NOTICE PLAN COMMISSION November 17, 2015

NOTICE PLAN COMMISSION November 17, 2015

PLAN COMMISSION

1 PROPOSED FLOOR PLAN
1/8"=1'-0"

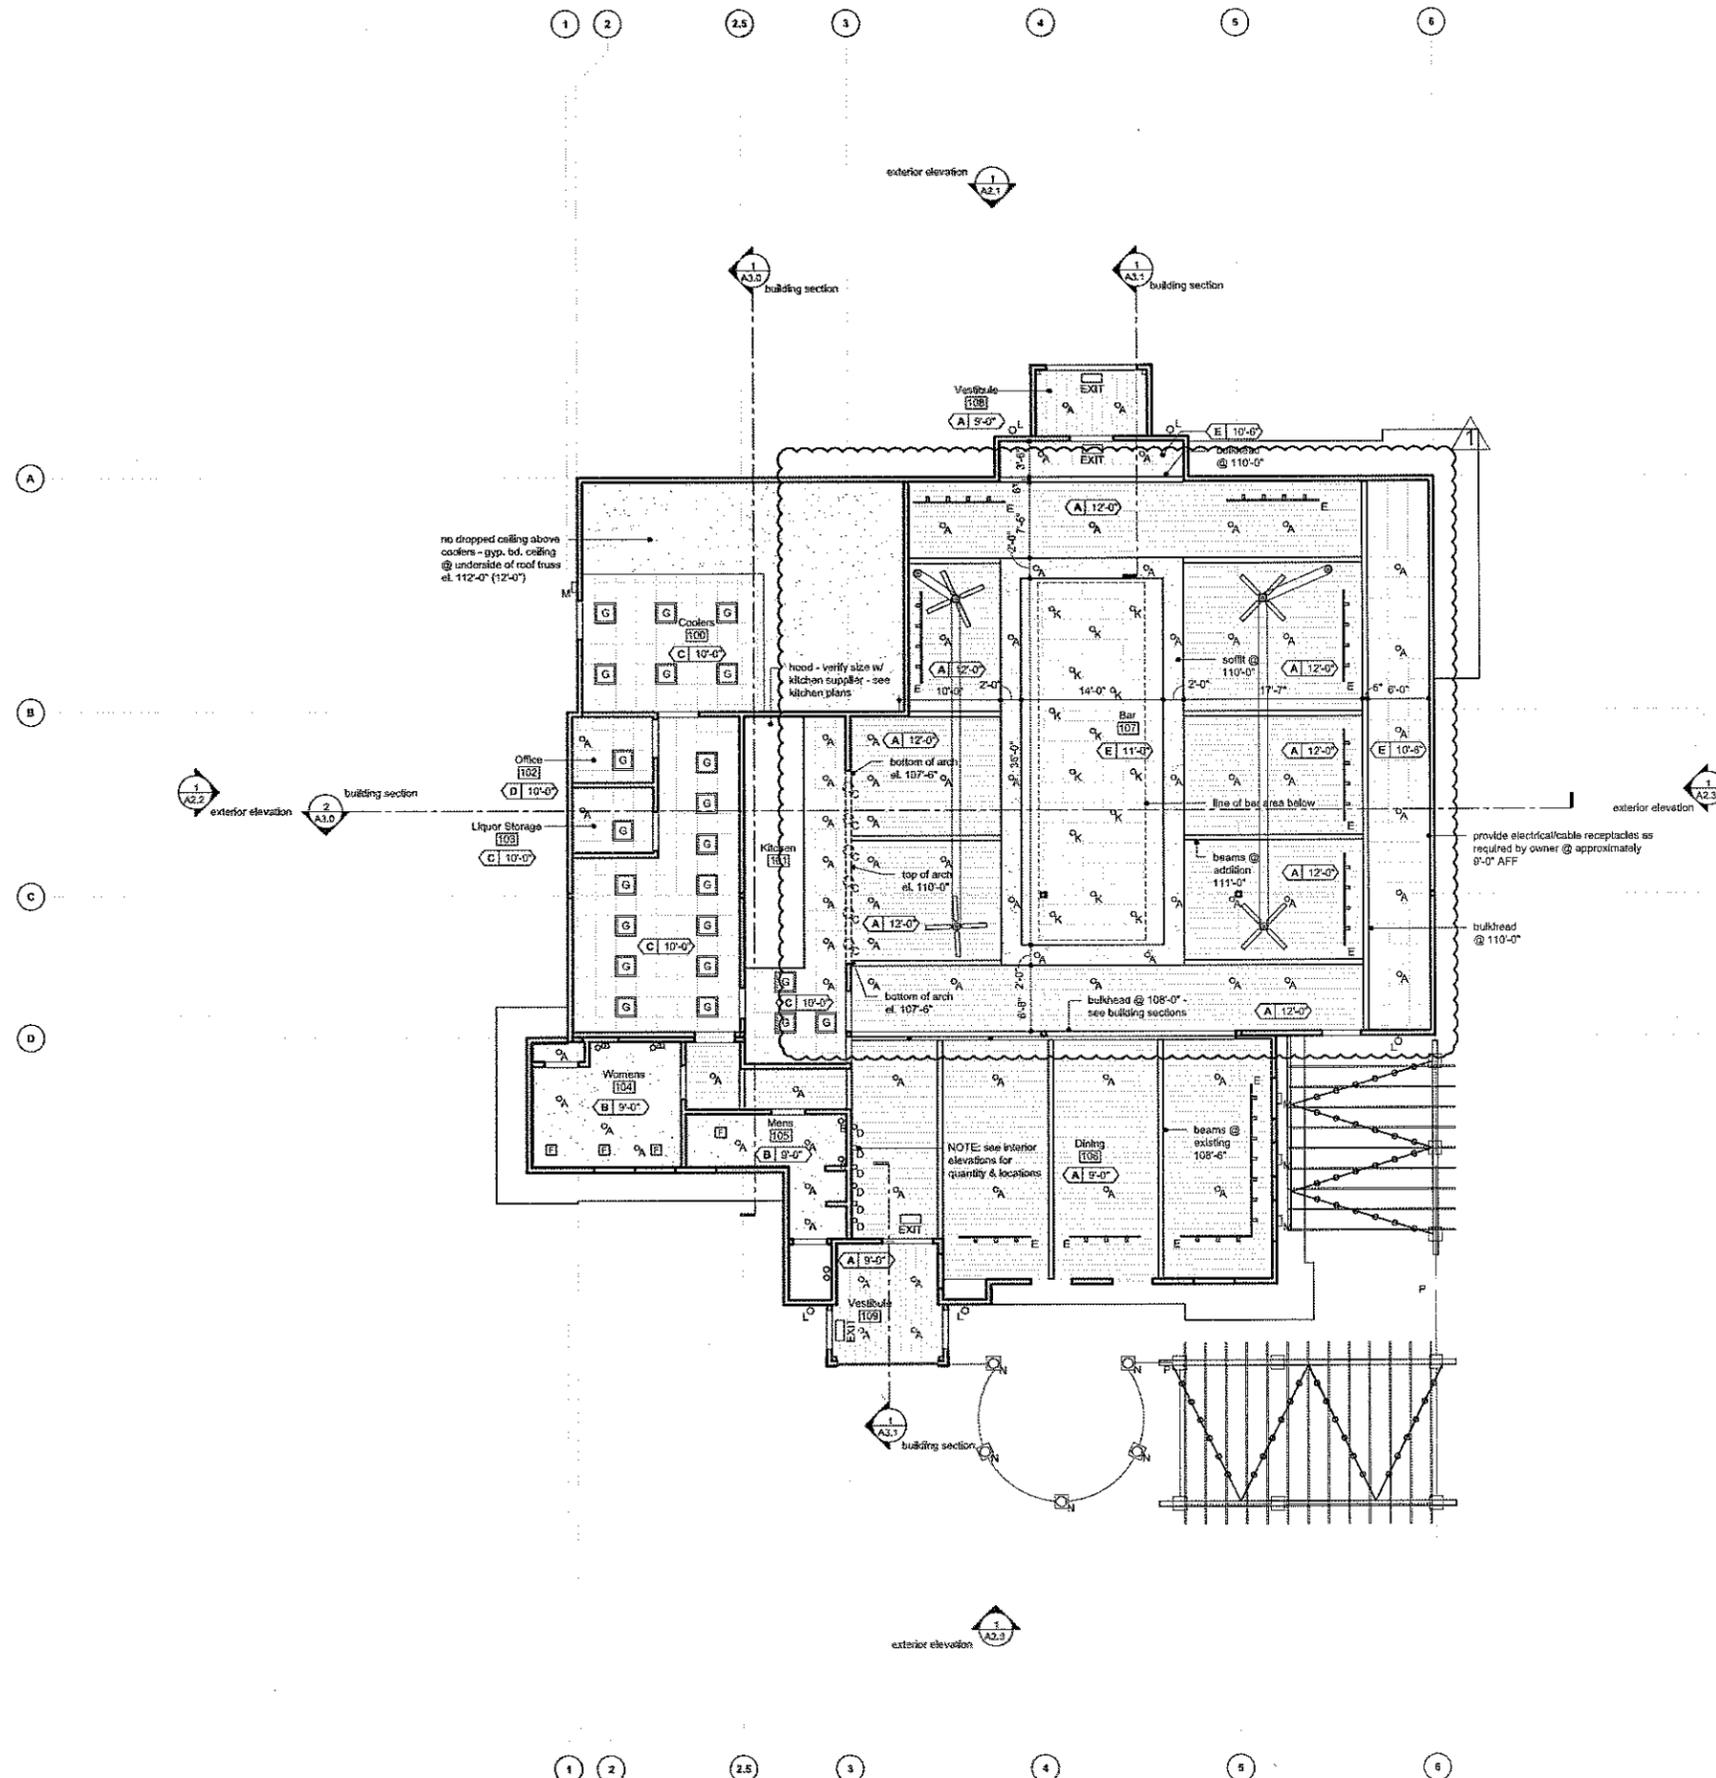
REVISION #1	
A1.0	REMOVAL OF FINISH WALLS, SHORTENING OF BOOTH WALL, EXTENSION OF CONCRETE & KITCHEN WINDOW SIZE
A1.1	WOOD CEILING CORRECTION
A1.2	DOOR ELEVATION
A2.1	DOOR ELEVATION
A2.2	DOOR ELEVATION
A3.1	DOOR ELEVATION HALF WALL HEIGHT & KITCHEN WINDOW/SWEEPINGS
A3.2	DOOR ELEVATION
A3.3	BOOTH EXTENSION HALF WALL HEIGHT & DOOR ELEVATION
A3.4	DOOR ELEVATION & FRAME TYPE
A3.5	NEW TRASH ENCLOSURE PLANS

SITE PLAN

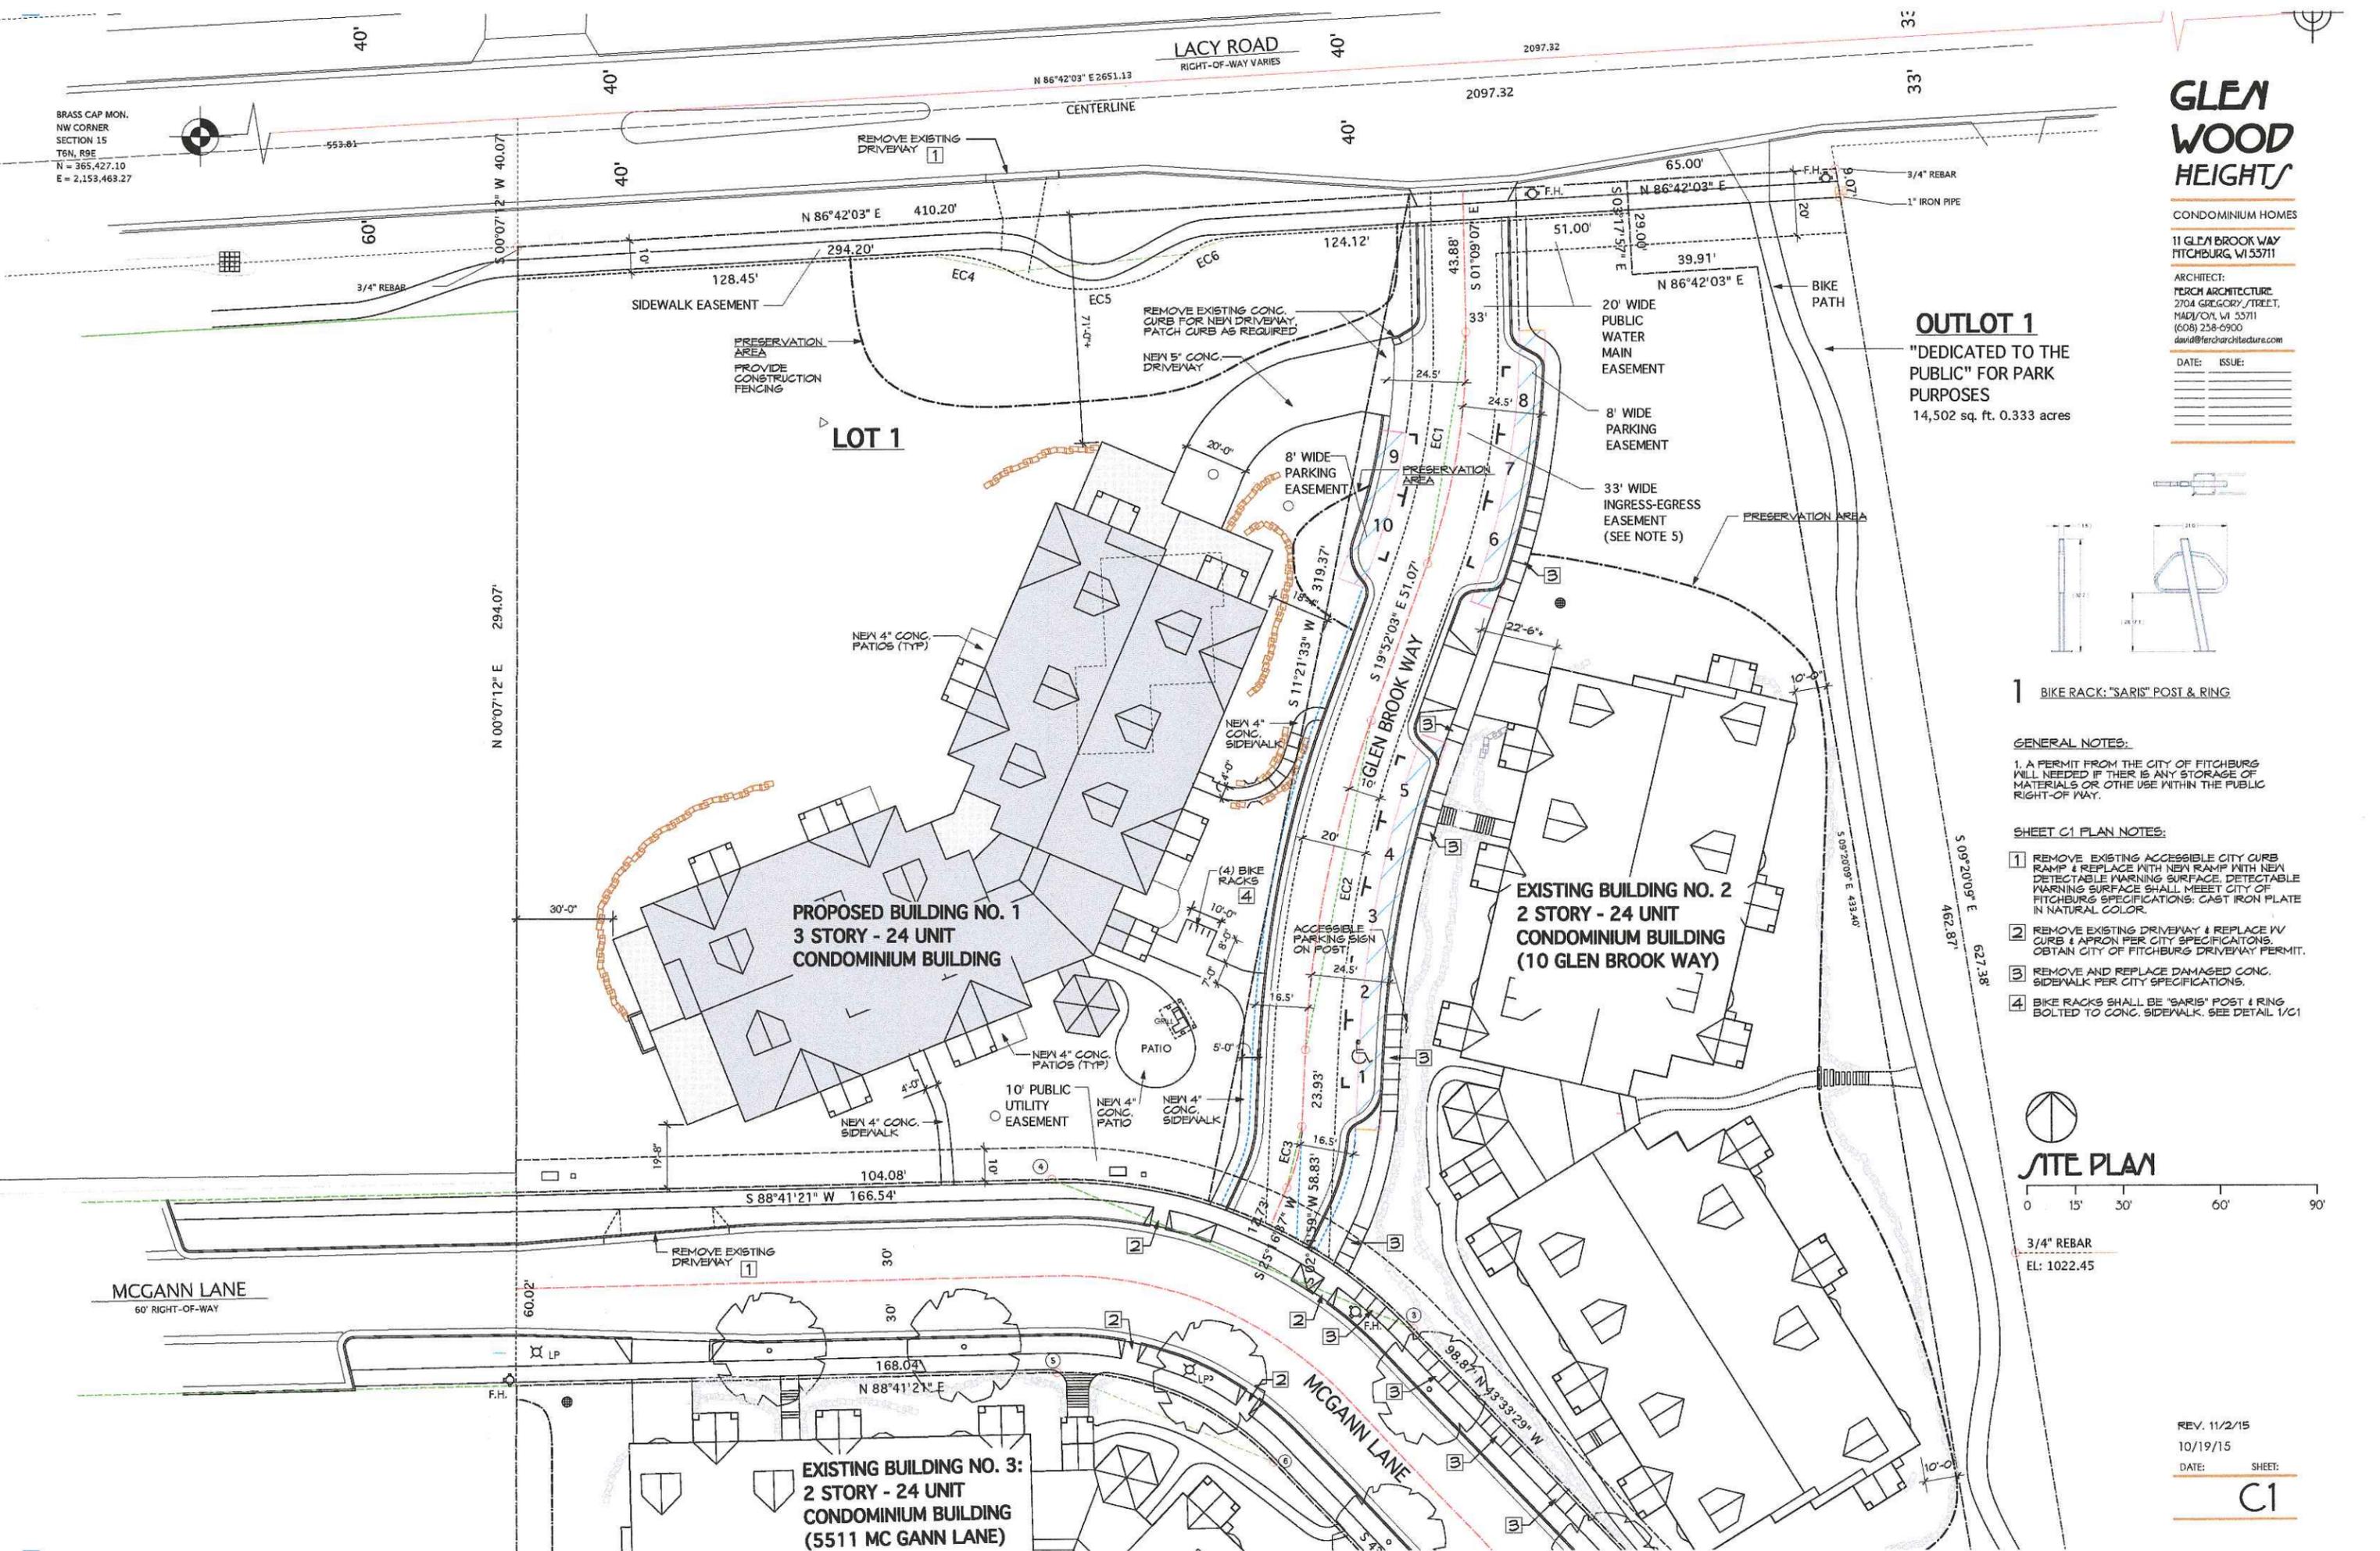
1. Driveway permits will be obtained for the removal of the driveways on Lacy Rd and McGann Ln. prior to the start of construction. A note has been added to sheet C1.

2. The revised plans note that a permit will be needed if there is any storage of, materials or other use within the public right-of-way. A general note has been added to sheet C1.

3. The areas of sidewalk along McGann Lane that are cracked and damaged will be replaced. Notes have been added to sheet C1.
4. The detectable warning fields will be replaced at all four curb ramps in the development. Notes have been added to sheet C1.
